ADDENDUM

DYSART DRAIN IMPROVEMENT PROJECT

Concept Design Study Selected Alternative

Prepared for:
FLOOD CONTROL DISTRICT OF MARICOPA COUNTY

Sheet Title: **Detention Basin Collector Channel**

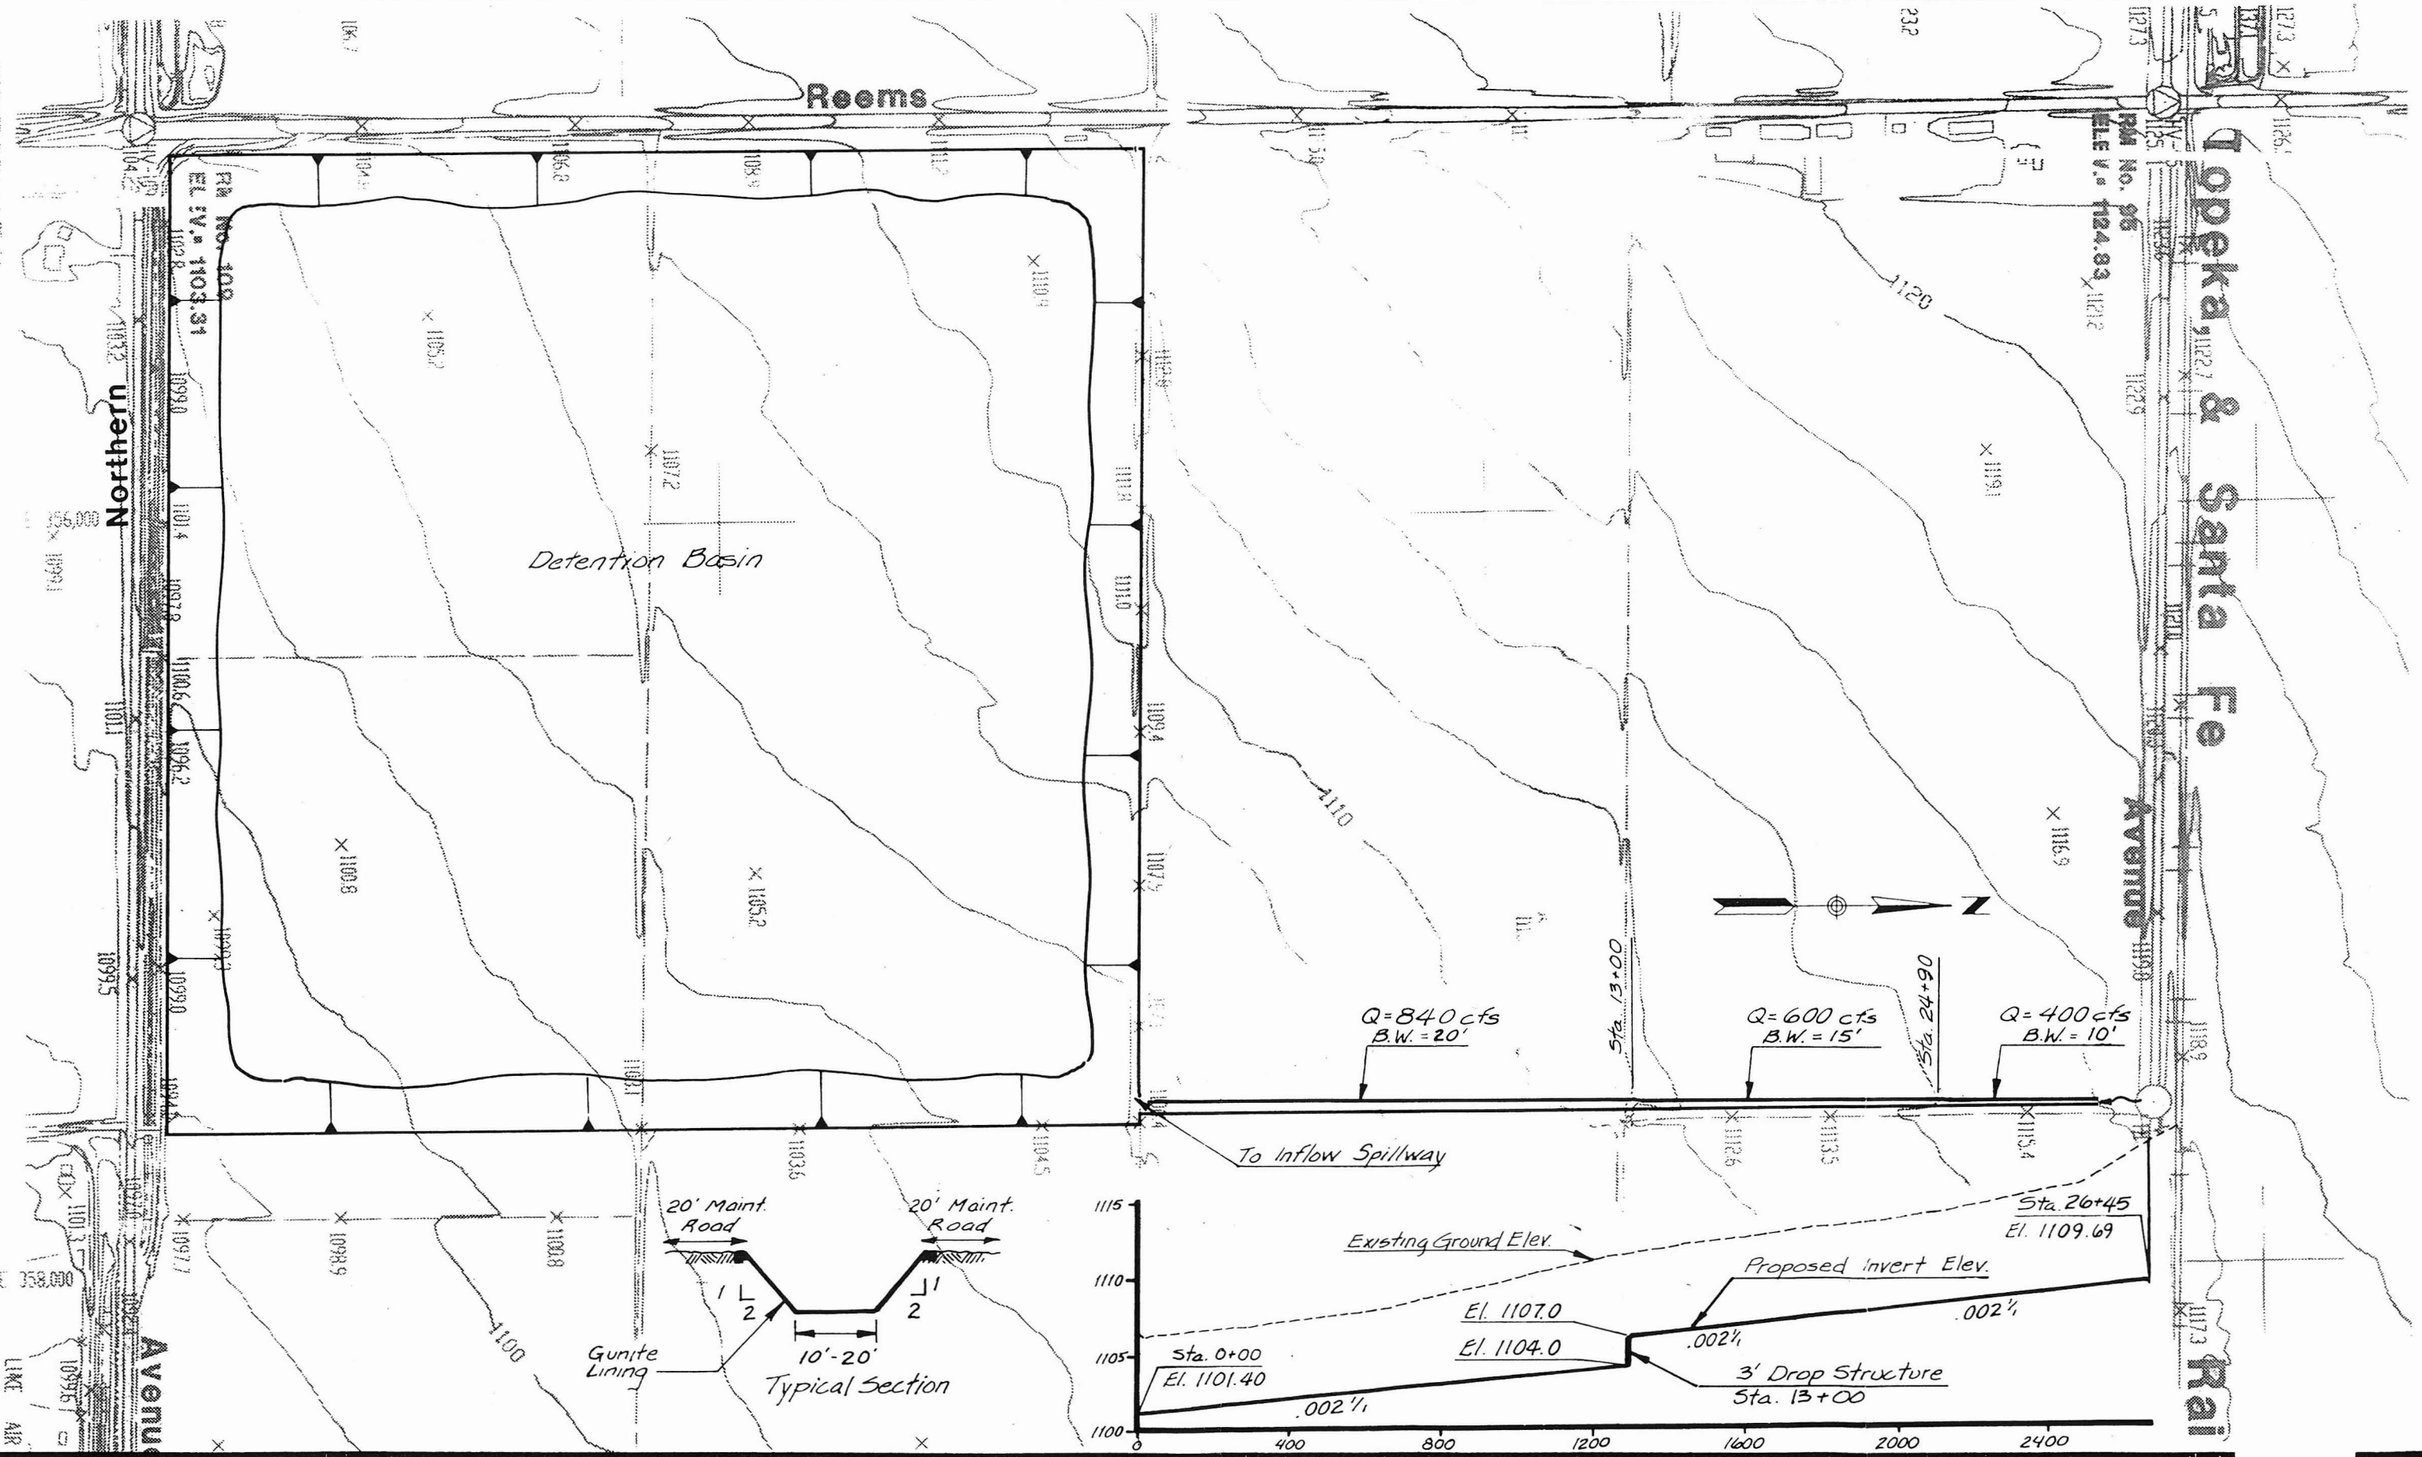
A new collector channel feature is proposed to be added to the project. The following exhibit shows the location, size and profile of the new channel. It is located parallel with and 1/2 mile east of Reems Road from the detention basin upstream to Olive Avenue.

The purpose of the channel is to capture flows that breakout of Reems Road and convey them to the basin. The channel will ensure that all of the flood flows which concentrate at Reems Road and Olive Avenue will reach the basin (with the exception of the 240 cfs which will flow east in Olive Avenue).

The channel is designed to convey 840 cfs. This flow was identified in the split flow model as that runoff which would exceed the capacity of Reems Road and Olive Avenue and flow southeasterly across the farm fields. The breakout flows will result in wide, shallow sheet flooding and will enter the channel in several locations. Consequently, there is no need to design the entire channel for 840 cfs. Therefore, the channel design peak discharges were reduced upstream of the basin (refer to the following exhibit). Also refer to Appendix C for the channel backwater analysis.

The channel was designed with one foot of freeboard. Therefore, the channel full capacity is greater than 840 cfs. The extra conveyance provides added insurance of capturing flows in the event that the berms on Reems Road wash out and much greater flow breaks out to the southeast.

A. A new collector channel feature should be added to the project that will collect and convey Reems Road breakout flows to the detention basin. The channel should extend approximately 1/2 mile from the detention basin upstream to the south side of Olive Avenue and should be constructed along the mid-section line, 1/2 mile east of Reems Road. This proposed alignment is parallel with the east edge of the basin which will maximize the runoff collected by capturing flows that might breakout of Reems Road upstream of Olive Avenue.

The capacity of the channel should be 840 cfs at the detention basin inflow structure. The capacity can decrease upstream of the basin since not all of the flow will be captured at the upstream end. Rather, the breakout flows will result in wide, shallow sheet flooding which will enter the channel in several locations. The recommended design flows decrease from 840 cfs at the basin to 400 cfs at Olive Avenue (refer to section 3.0).

The channel should be designed with one foot of freeboard. The freeboard will give the channel additional capacity to convey flows in excess of 840 cfs. This will provide extra capacity for the case where the berms on Reems Road wash out which would result in a breakout of more than 840 cfs.
